**Agenda**  
**Bar Harbor Planning Board**  
**Wednesday, February 5, 2020 at 4:00 PM**  
**Council Chambers - Municipal Building**  
**93 Cottage Street**

## **Subdivision Pre-Application Sketch Plan for SD-2019-03 Review – Destination Health**

### **Subdivision Pre-Application Sketch Plan for SD-2020-01 Review – Maller/MacQuinn Subdivision**

### **Completeness Review under Site Plan Review for SP-2019-07 – Triple Chick Farm (driveway/stream crossing)**

1 **FIRST FLOOR PLAN**  
Scale: 1/4" = 1'-0"

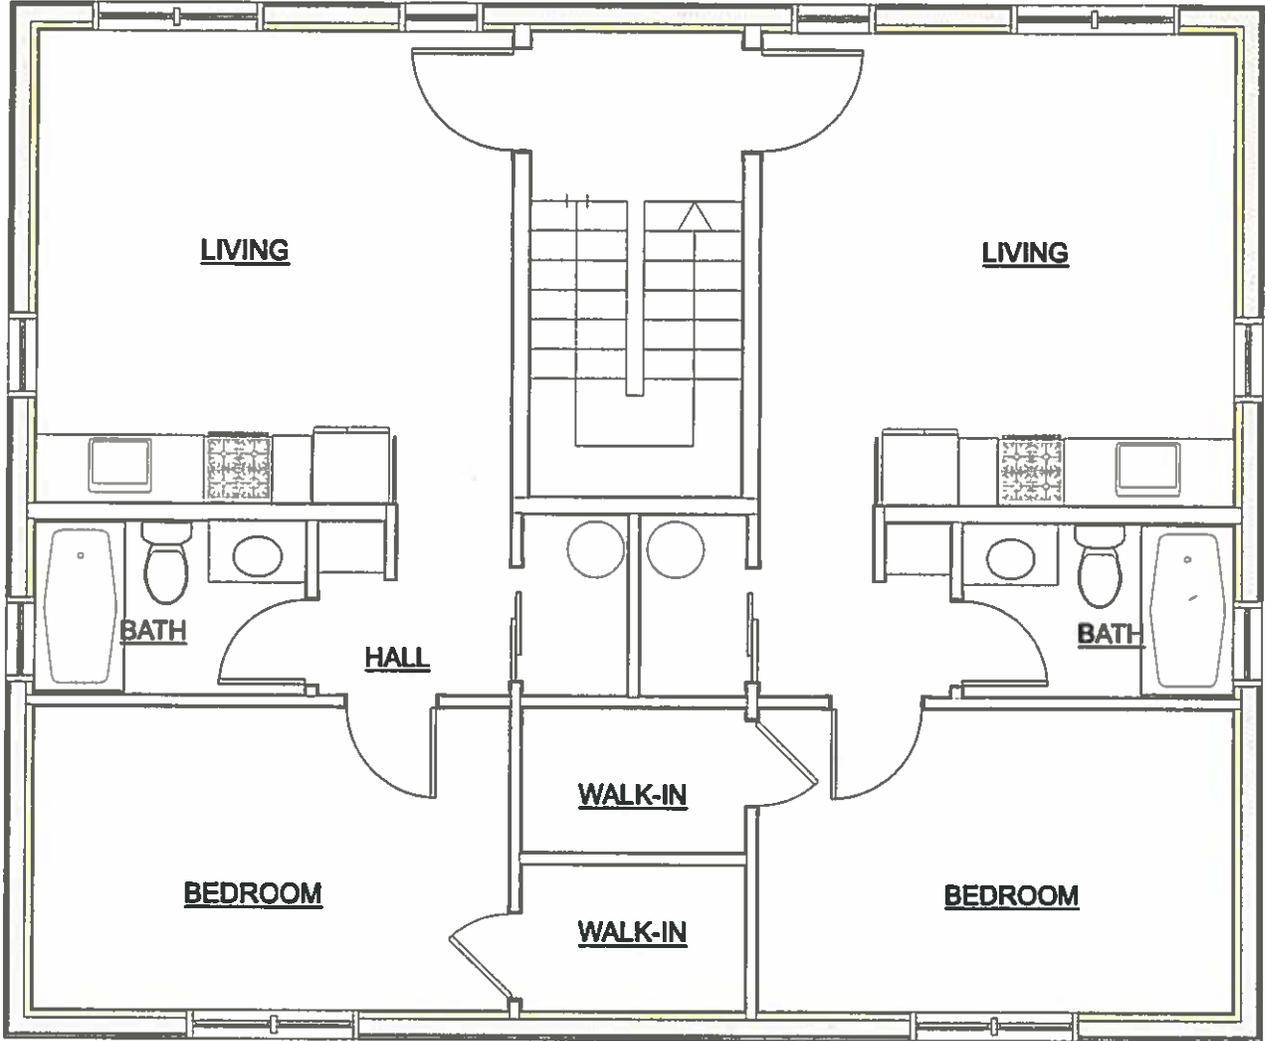
- Building will have to be sprinkled. Design of sprinkler system will dictate size of water line.
- With one stairway for the second floor, will need a fire alarm system. If two separate stairways out of the second floor, smoke and CO<sub>2</sub> detectors will suffice.
- Will need to show distance from nearest fire hydrant (corner of Cottage and Eden). Staff agrees there is adequate water pressure there.
- Stormwater question: will this building be on a slab, or have a basement? If basement, assume there will be a sump pump; staff has question on where/how that would discharge, if so.
- Water/wastewater OK with lines coming in from Brewer Avenue.
- PD has no concerns with parking setup.

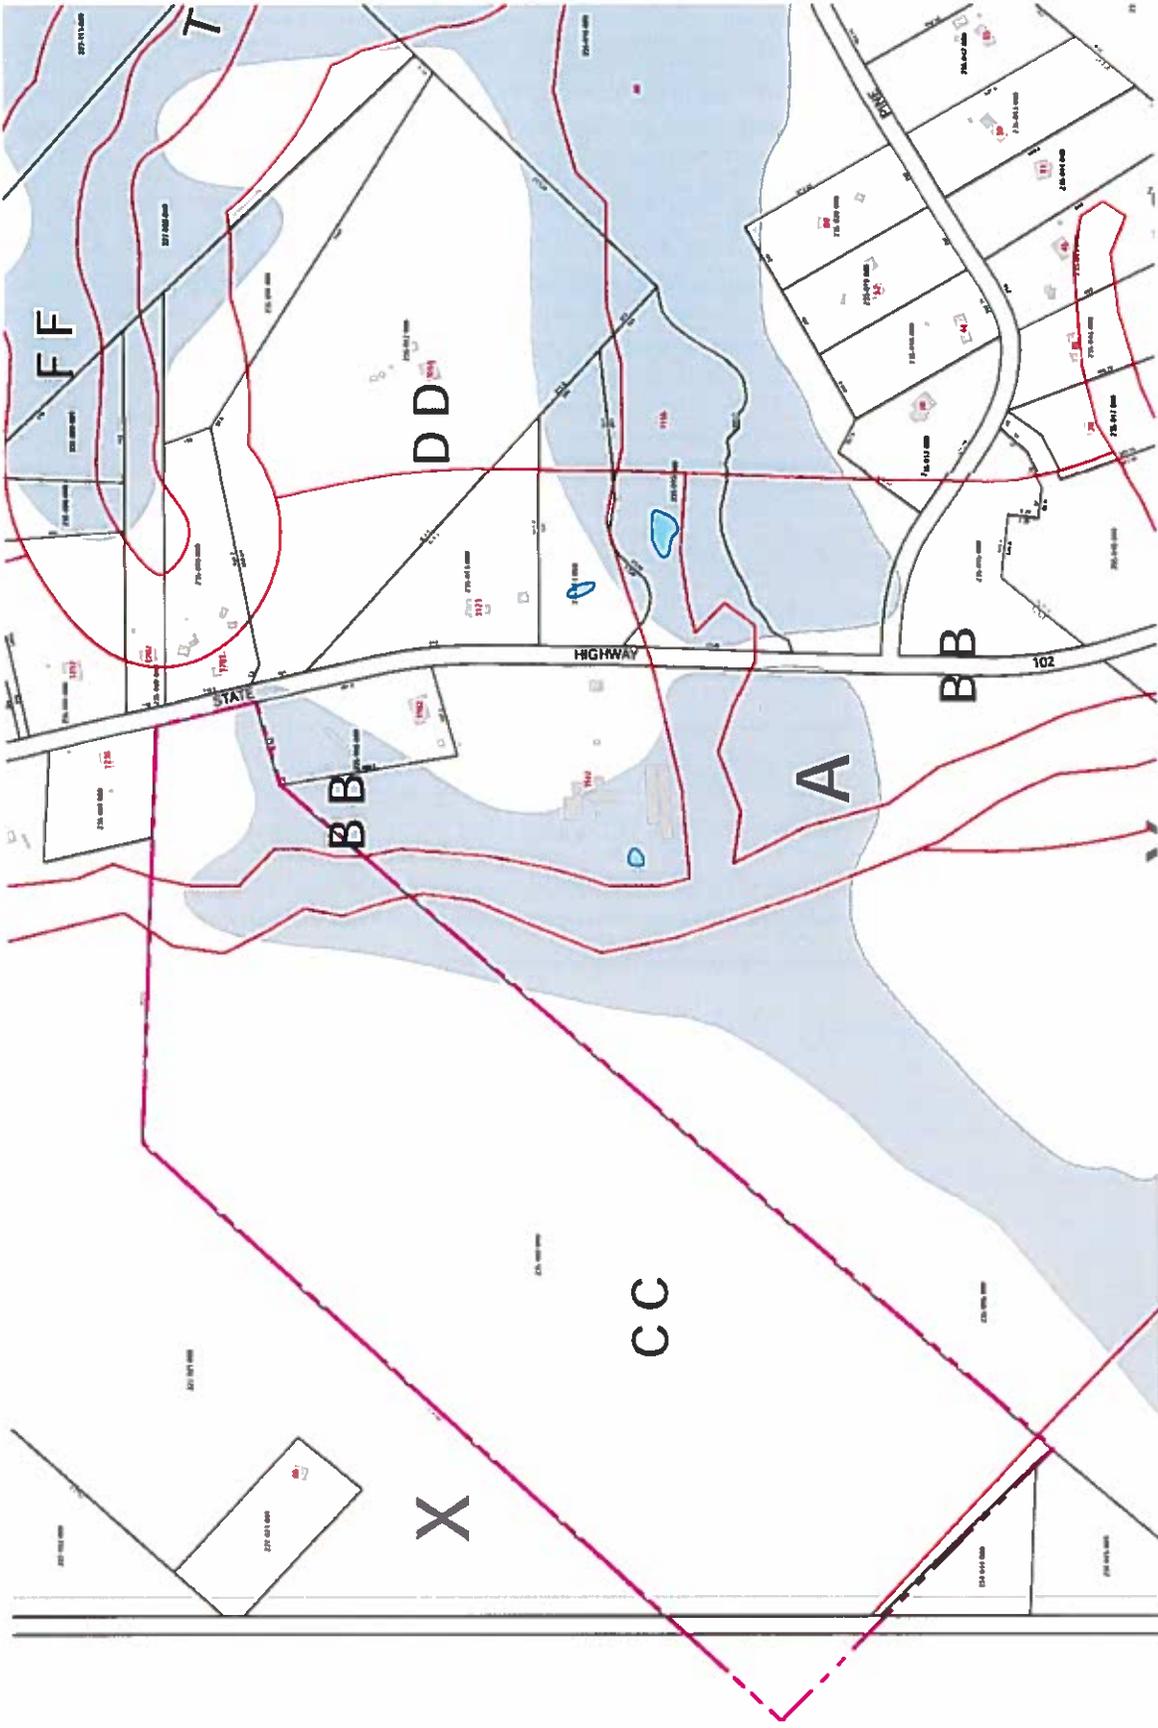
S - Add 15 foot radii to north side of proposed driveway to accommodate turning vehicles.
